AG-SB-2017-03-B-EN – MT03 control rod**Category B****EFFECTIVE DATE**

This Service Bulletin is applicable for all MT03 and converted MT03 to MTOsport until 12 / 2007, where the control rod is cut diagonally (see fig.1).

Fig. 1: old control rod with diagonally cut

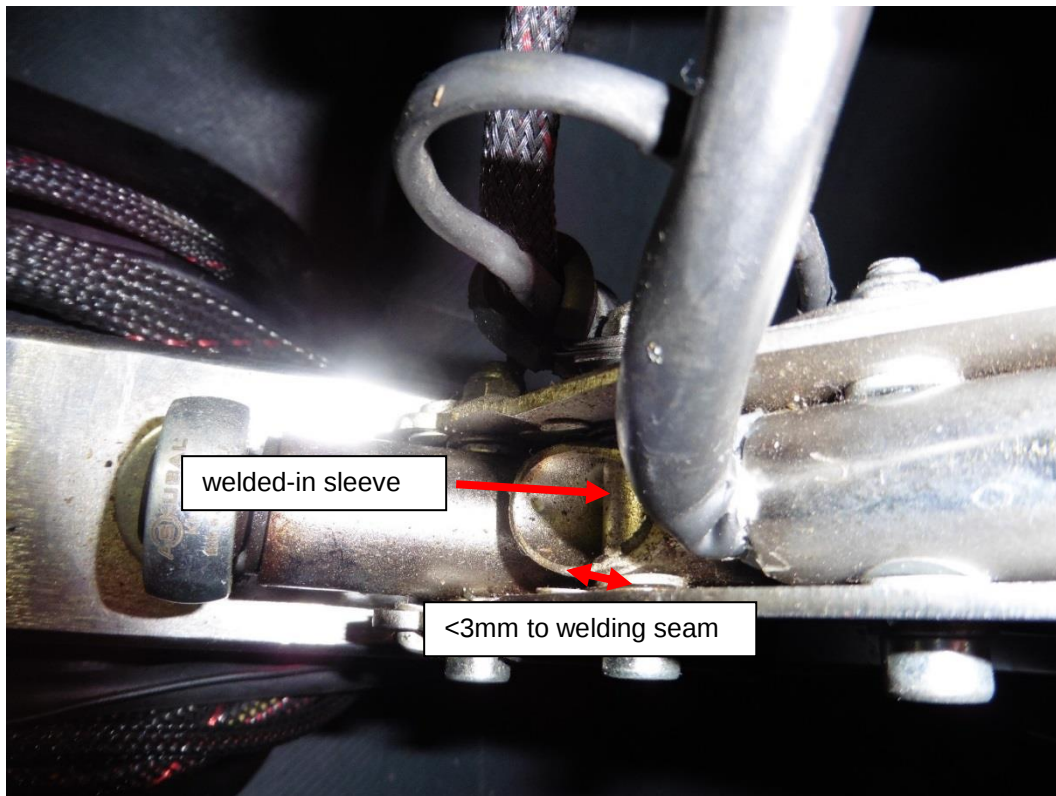
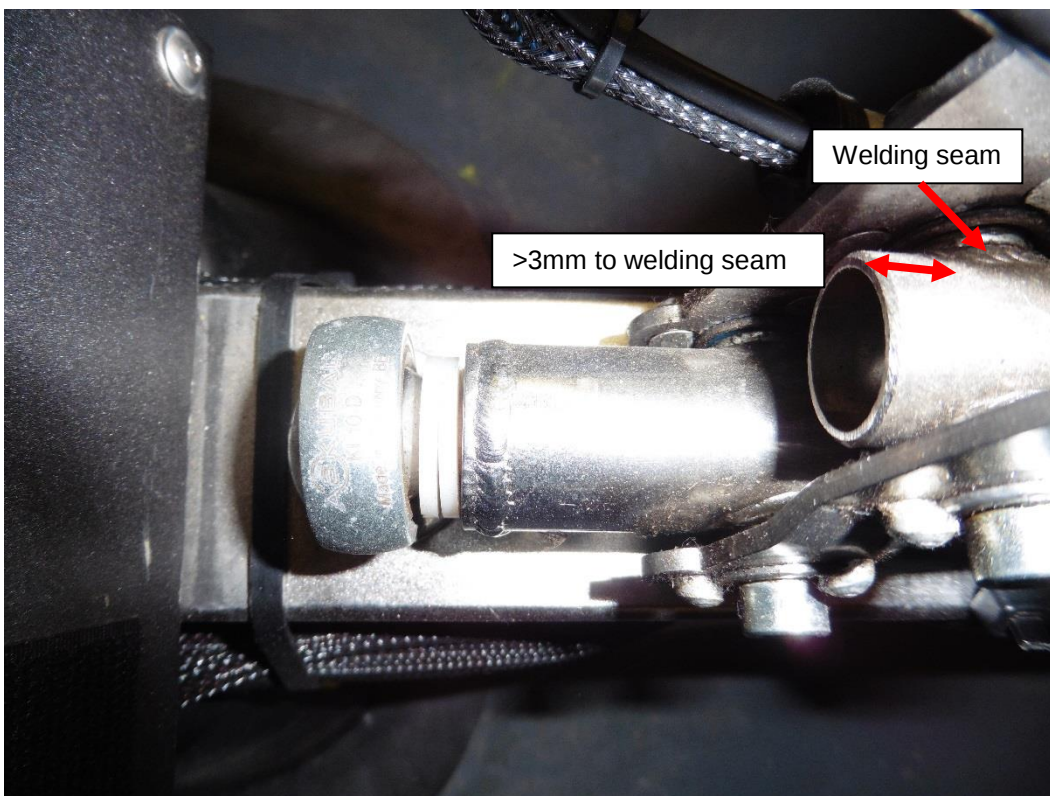
- Inspect that the welded-in sleeve inside the end of the tube is secure, and no evidence of weld failure.
- Inspect if the control rod has been cut down more than 3mm between the end of the rod and the outer wall of the welding seam.
- Rectification: replace the control rod if cut down limit of 3mm is exceeded.

- 1 Remove the attachment bolt between the tube and the side plates to the stick.
- 2 Inspect that the welded-in sleeve inside the end of the tube is secure, and no evidence of weld failure.
- 3 Inspect if the control rod has been cut down more than 3mm between the end of the rod and the outer wall of the welding seam.
- 4 Rectification: If the cut down limit of 3mm is exceeded, remove the control rod (camshaft) and replace with a new control rod in line with the MMM. Contact AutoGyro service to obtain a matching part.
- 5 If the control is acceptable for continued service, refit the bolt with a new nylock nut as per the MMM.
